**CITY OF EL PASO, TEXAS
AGENDA ITEM
DEPARTMENT HEAD'S SUMMARY FORM**

Contract Change Order Coversheet /Checklist City of El Paso Capital Improvements Department

CITY OF EL PASO CONSTRUCTION CHANGE ORDER

RFI #110: Electrical Services Issue

MCRAE INBOUND AND OUTBOUND STATION - ELECTRICAL SITE PLAN

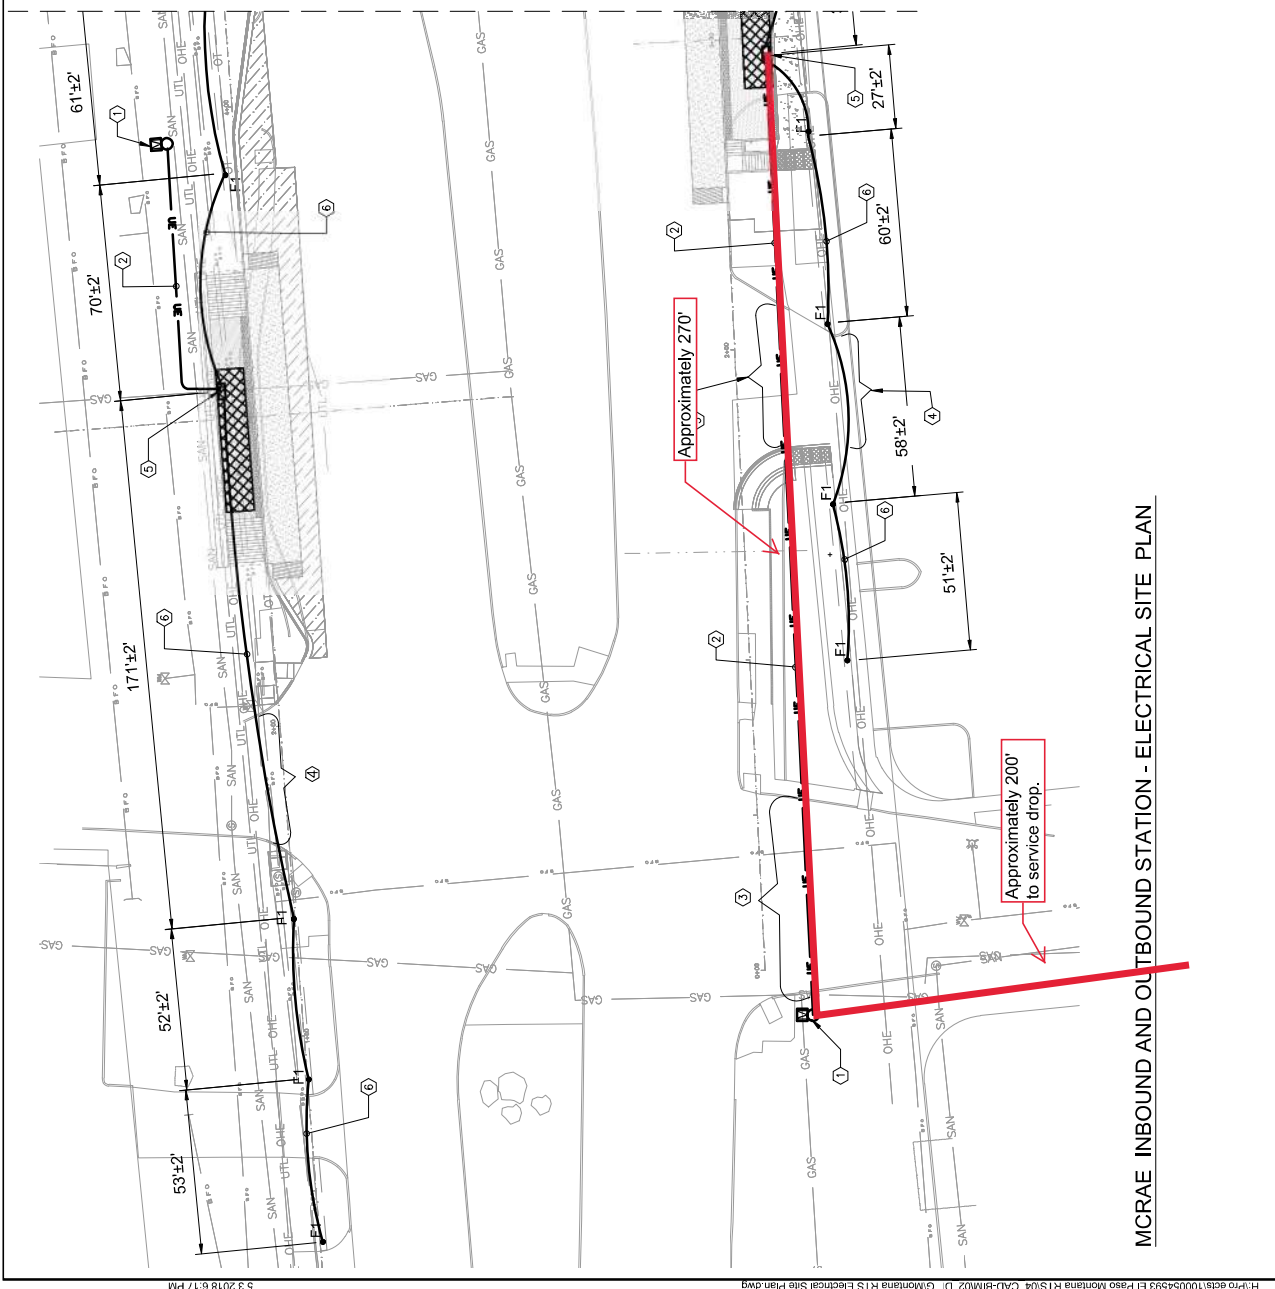
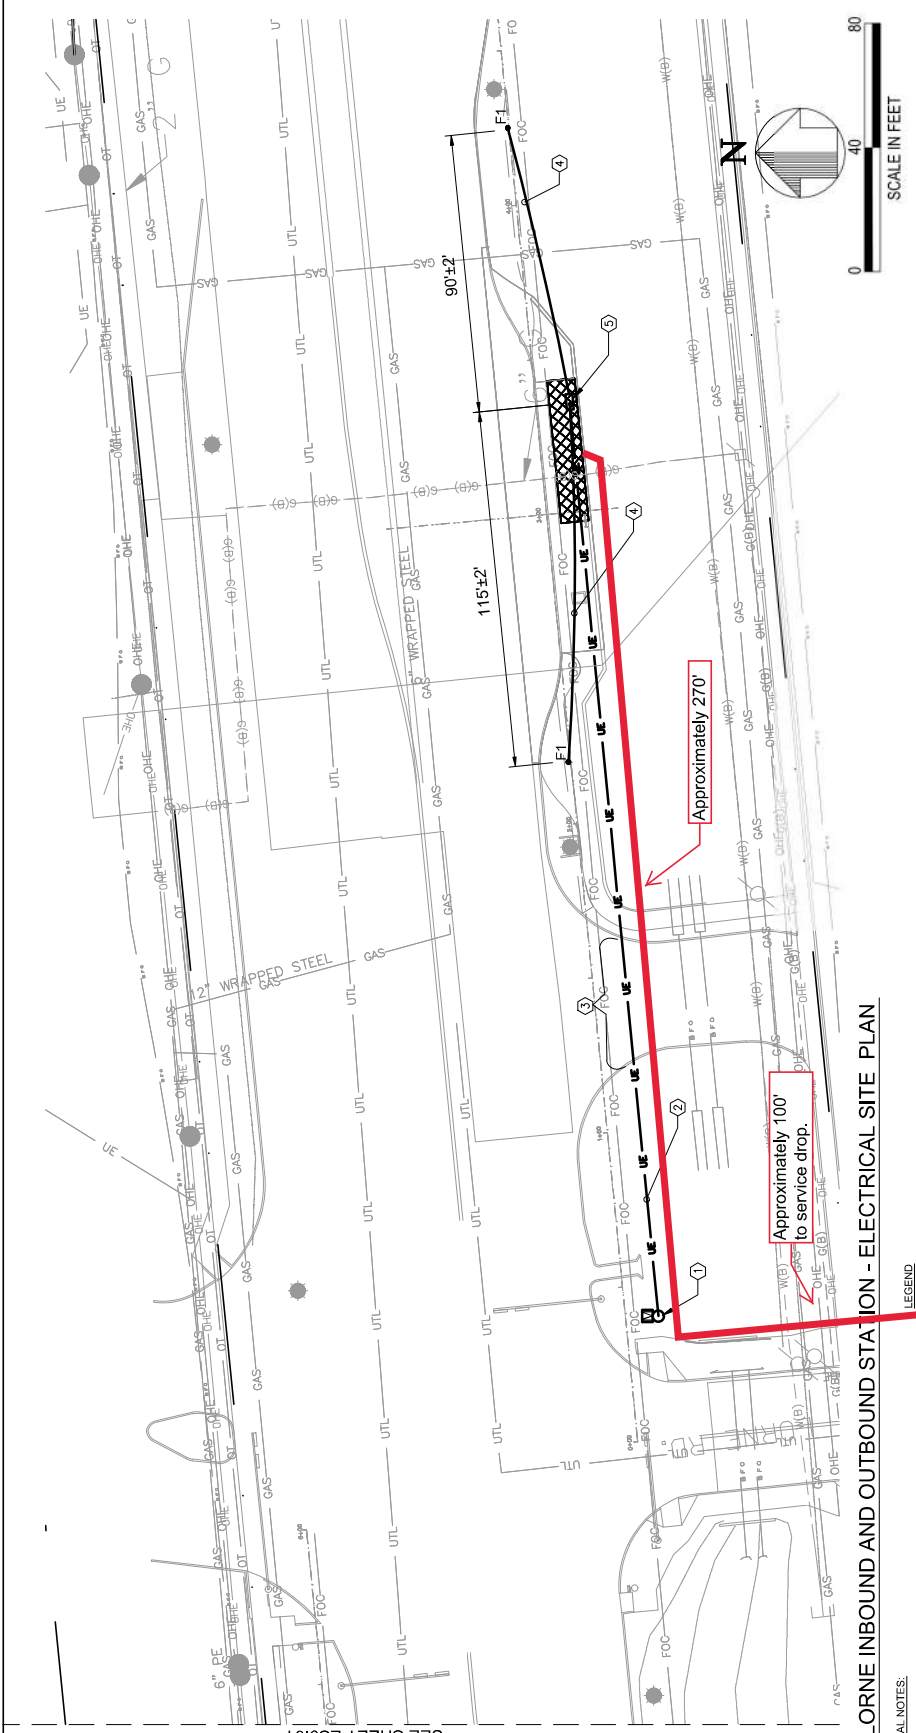
| Question | <p>Question from Rene Gonzalez Venegas Engineering Management and Construction on Tuesday, Apr 20, 2021 at 05:44 PM MDT</p> <p>Alex, As mentioned previously, please advise how to proceed with several stations (McRae, Huckleberry, Tierra Este, and Lorne) that the electrical service is too far away. Thank you, RG</p> |

Atkins Response:
Voltage drop calculations were conducted assuming 80 amp electrical service (80% of the 100-amp Main Circuit Breaker per NEC). Per NEC Articles 210.19(A) and 215.2(A), the recommended maximum voltage drop for the branch circuit and feeder is 5 percent. The present 3#1 feeder size is not adequate and would provide a voltage drop percentage that exceeds the NEC recommended percentage.

Based on the revised distances indicated for the meter location, the service feeder size needs to be increased. The following are the recommendations:

| Official Response | <p>Response from Gerardo Garcia ECM International, Inc. on Tuesday, Jun 29, 2021 at 09:01 AM MDT</p> <p>CID is in agreement in using the 3" conduit in lieu of the 2" conduit. Compensation for the 3" conduit will be done under the current contract item BB2-209 ELP-25-3 (PVC)(SCHED 40)(3"). Item for 3" conduit will be added to Base Bid 1 via a change order.</p> |

COPIA INBOUND AND OUTBOUND STATION - ELECTRICAL SITE PLAN

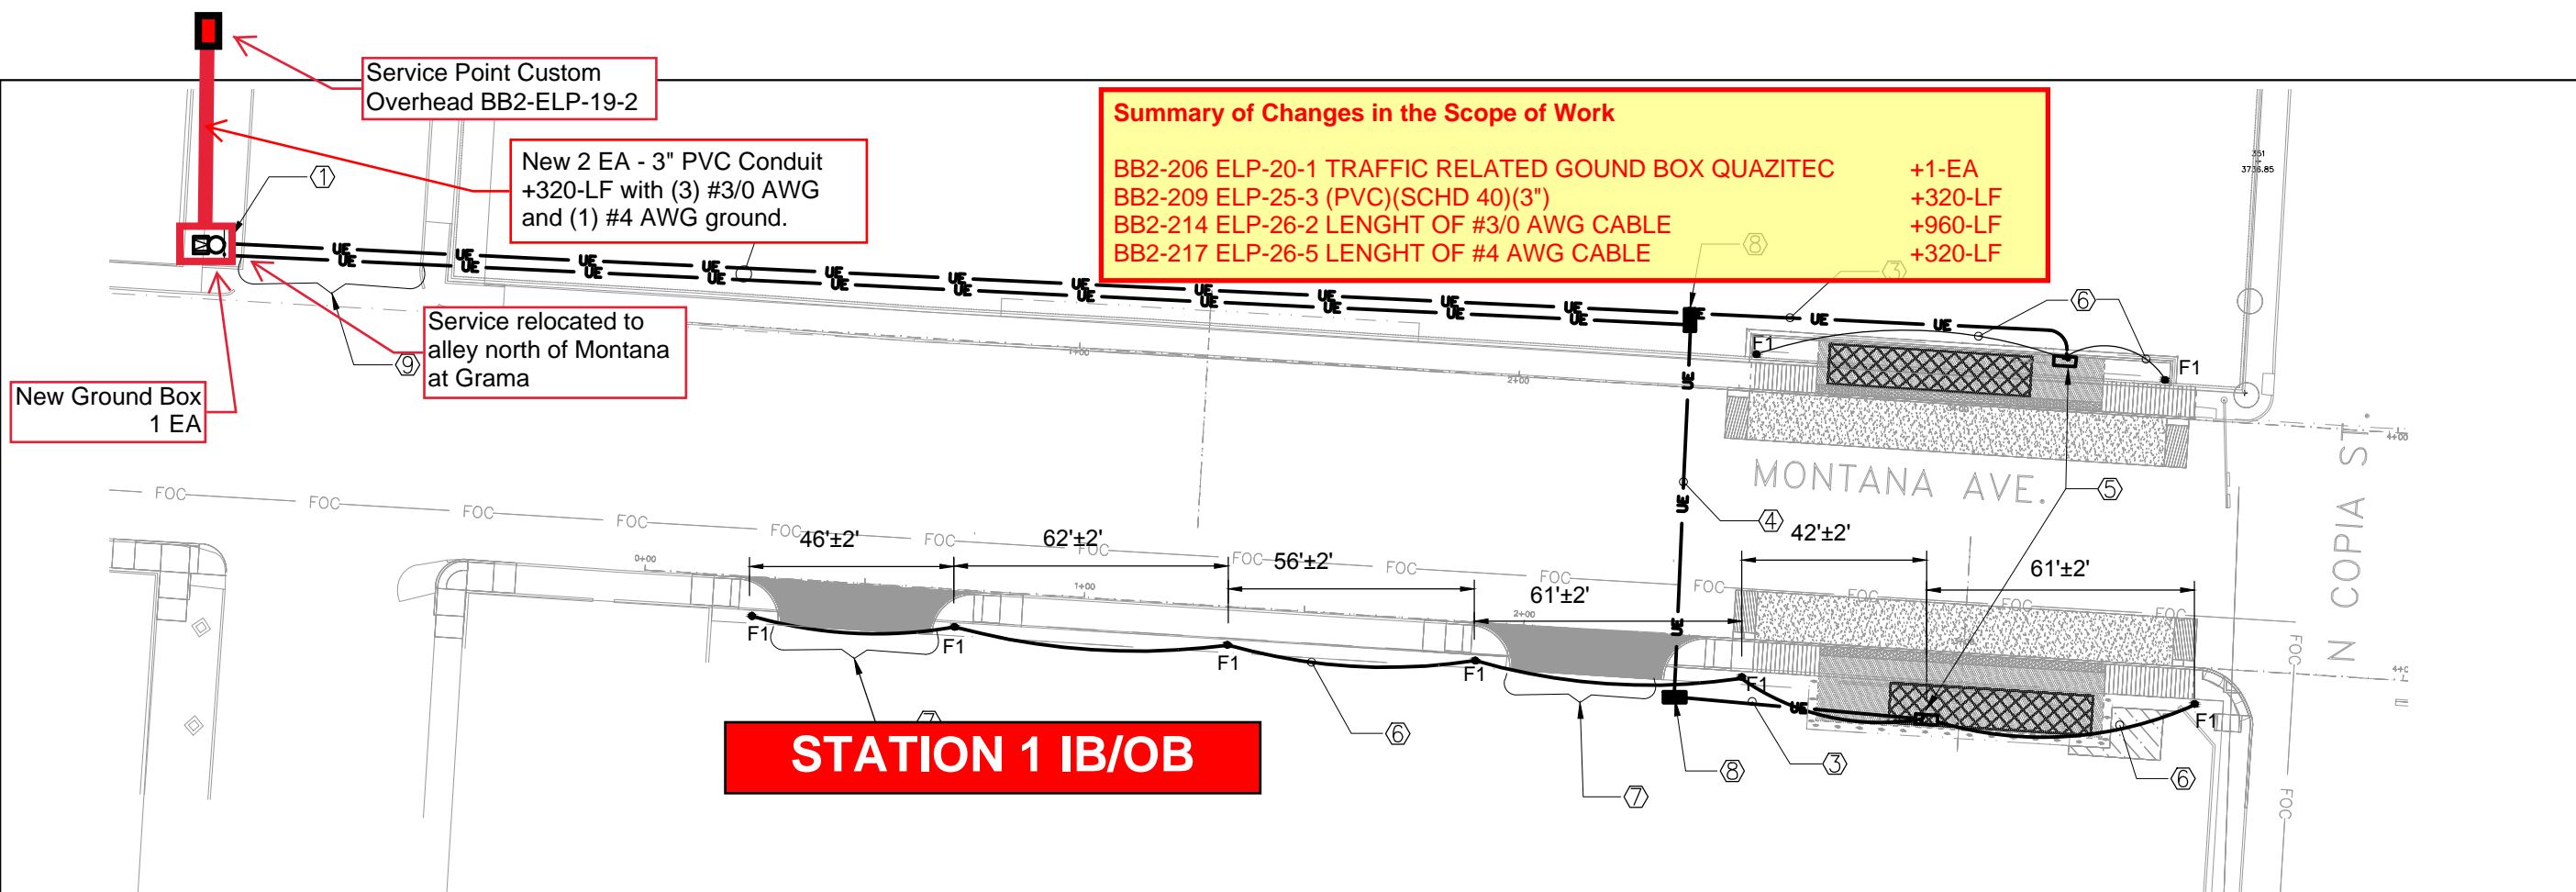
- ① PROVIDE ELECTRICAL SERVICE AS INDICATED ON DETAIL 2 SHEET E0.02
- ② PROVIDE (2) 3"C PVC SCHEDULE 40 EACH. WITH (3)#3/0 AWG AND (1)#4 GND FROM SERVICE RACK TO PULLBOX.
- ③ PROVIDE (1) 3"C PVC SCHEDULE 40, WITH (3)#3/0 AWG AND (1)#4 GND FROM PULLBOX TO ELECTRICAL CABINET
- ④ JACK/BORE AND PROVIDE (1) 3"C PVC SCHEDULE 40 WITH (3)#3/0 AWG AND (1)#4 GND COORDINATE WITH TXDOT.
- ⑤ TERMINATE ELECTRICAL FEEDERS IN 100A MAIN BREAKER PANEL INSIDE ELECTRICAL DISTRIBUTION CABINET. REFER TO SHEET E0.03 FOR MORE INFORMATION.
- ⑥ PROVIDE (1) 1" C. WITH (2)#10 AWG AND (1)#10GND CIRCUIT AS INDICATED ON SHEET E0.04
- ⑦ BORE AND PROVIDE (1) 1"C PVC SCHEDULE 40 WITH (2)#10 AWG AND (1)#10 GND.
- ⑧ PROVIDE 24"X12x12" QUAZITE PC STYLE POLYMER CONCRETE ASSEMBLY TRAFFIC RATED PULLBOX
- ⑨ JACK/BORE AND PROVIDE (2) 3"C PVC SCHEDULE 40 EAC WITH (3)#3/0 AWG AND (1)#4 GND COORDINATE WITH TXDOT.

MONTANA RAPID TRANSIT SYSTEM
HUCKLEBERRY - STATION 2 ELECTRICAL SITE PLAN

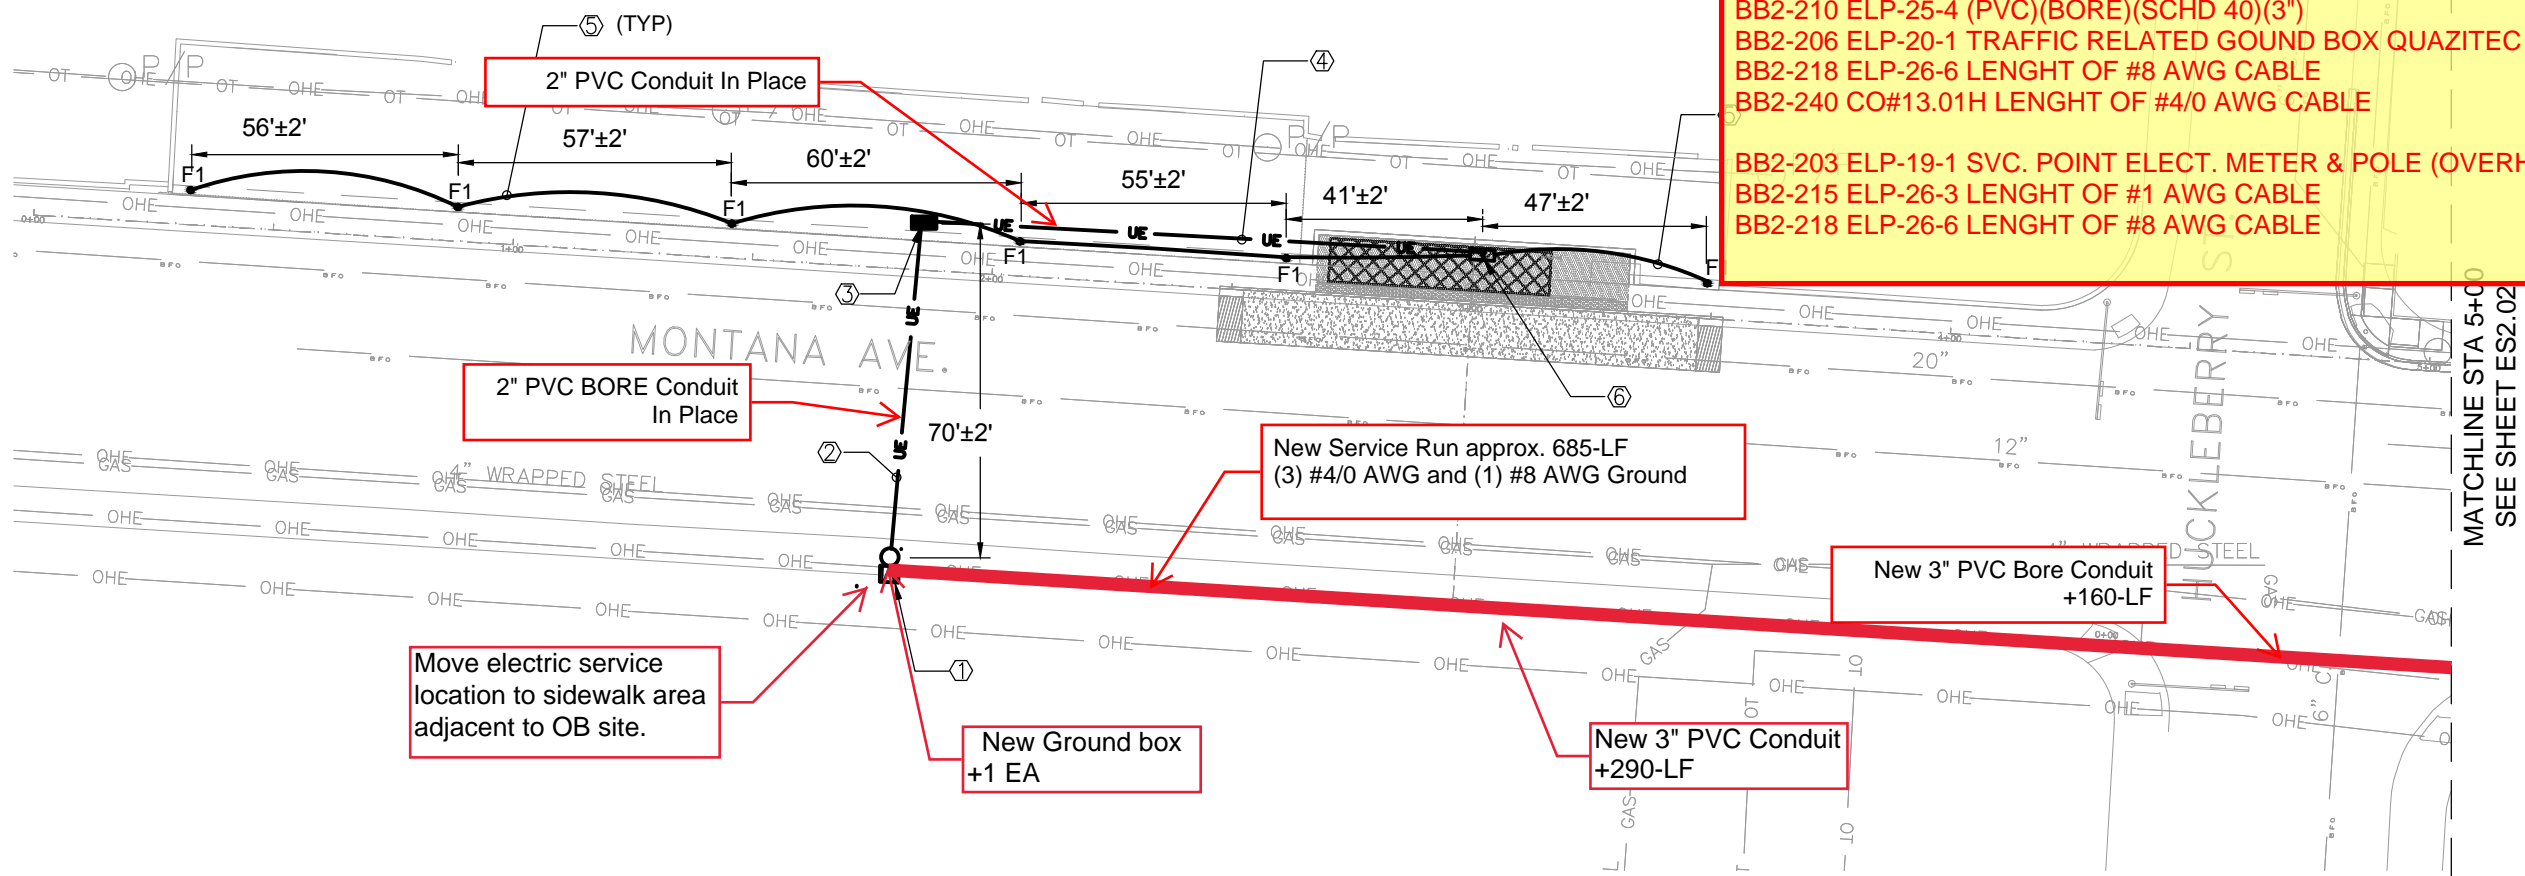
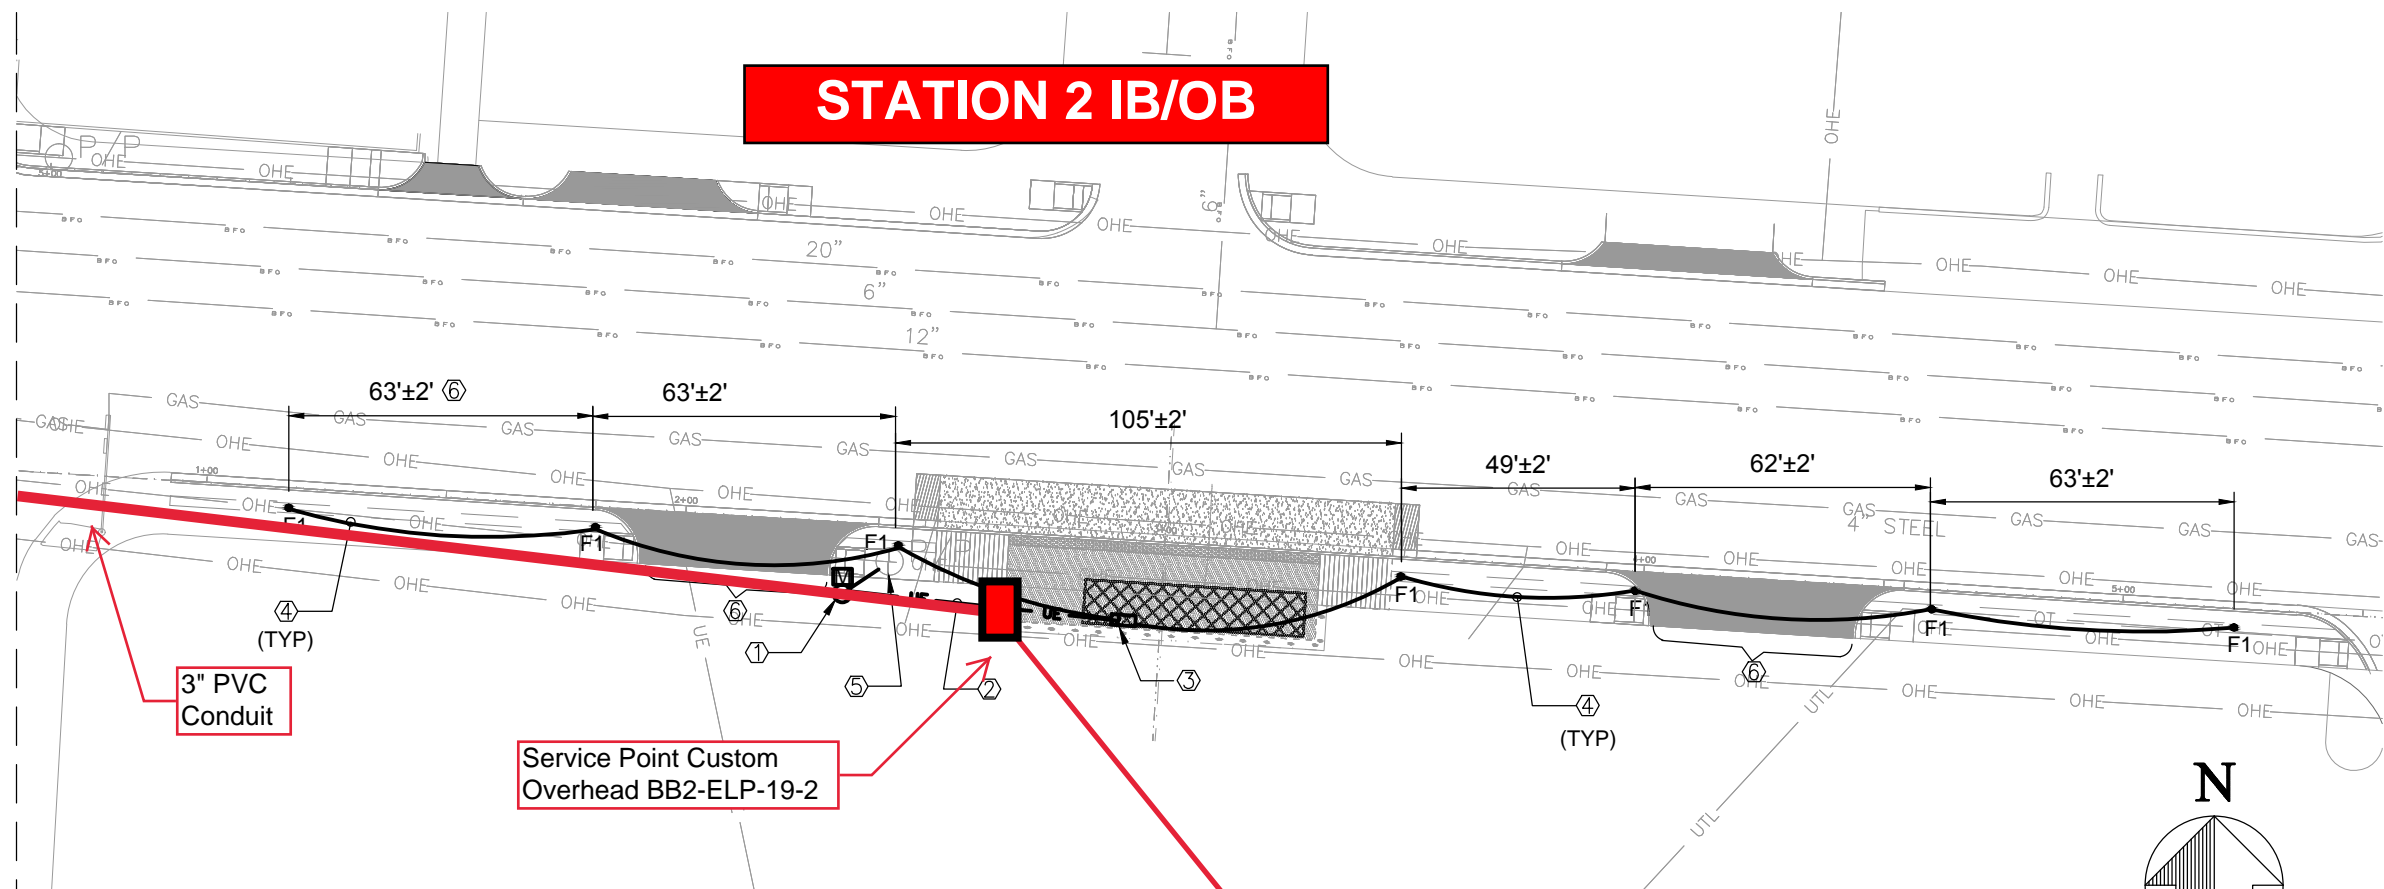
- ① PROVIDE ELECTRICAL METE E0.02
- ② JACK/BORE AND PROVIDE (GND.
- ③ PROVIDE 24\"X12x12\" QUAZIT TRAFFIC RATED PULLBOX
- ④ PROVIDE (1) 2\" C PVC SCHE
- ⑤ PROVIDE (1) 1\" C. WITH (2)# SHEET E0.04
- ⑥ TERMINATE ELECTRICAL FE ELECTRICAL CABINET. REF
